Access Compliance Report

Public Rights-of-Way

Intersection ID: 26215	Main Street: RAINTREE_LN	Cross Street: WHITETHORN_DR	Location:	N
ADA ID: 8BE6E4695DAE	Ramp Type: BlendTrans1	Initial Pass/Fail: Fail	Overall Compliance: No	Severity Score: 47.5

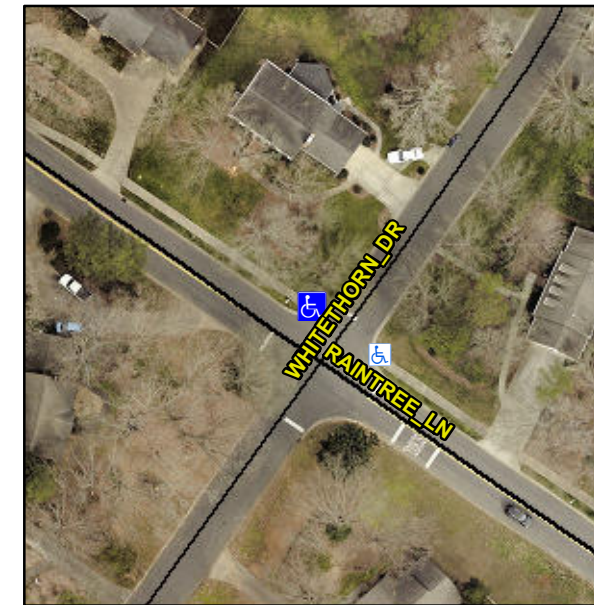
Not Found, R304.5.1, R304.5.3

Compliance	Description	Data	Compliance	Description	Data
N/A	Ramp Length (in)	51.0	Yes	BlendTrans Slope (%)	2.4
No	Ramp Width (in)	24.0	No	BlendTrans XSlope (%)	5.9
N/A	Flare Type LT	N/A	N/A	Flare Type RT	N/A
N/A	Flare Slope LT (%)	N/A	N/A	Flare Slope RT (%)	N/A
N/A	Flare Traversable LT?	N/A	N/A	Flare Traversable RT?	N/A
N/A	Landing Length (in)	N/A	N/A	DWS Provided?	N/A
N/A	Landing Width (in)	N/A	N/A	DWS Contrast?	N/A
N/A	Landing Slope (%)	N/A	N/A	DWS Length (in)	N/A
N/A	Landing X Slope (%)	N/A	N/A	DWS Full Width?	N/A
N/A	Landing Curb? (Y/N)	N/A	N/A	DWS Offset (in)	N/A
N/A	Shared Landing?	N/A			
N/A	Gutter Ponding?	N/A	N/A	Gutter Slope (%)	N/A
N/A	Gutter Lip Ht (in)	N/A	N/A	Gutter X Slope (%)	N/A
N/A	Painted X Walk1?	No	N/A	Painted X Walk2?	N/A
	X Walk 1 Direction	To SE		X Walk 2 Direction	N/A
	X Walk 1 Width (in)	N/A		X Walk 2 Width (in)	N/A
	X Walk 1 Slope (%)	1.0		X Walk 2 Slope (%)	N/A
	X Walk 1 X Slope (%)	5.9		X Walk 2 X Slope (%)	N/A

N/A	Ramp inside XWalk1?	N/A	N/A	Ramp inside XWalk2?	N/A
	Road Slope (%)	5.9		Clear Space?	N/A
	Road X Slope (%)	1.0	N/A	Clear Space to XWalk (in)	N/A
N/A	Any Obstructions?	N/A	N/A	Storm Grate/Utility Hazard?	N/A
	Obstruction Type			Storm Grate/Utility Type	
		N/A			N/A
			Yes	Surface Condition? (G/P)	Good
			No	Curb Slope (%)	9.3

Remove & Replace Curb Ramp With Two New Directional Ramps or Equivalent.
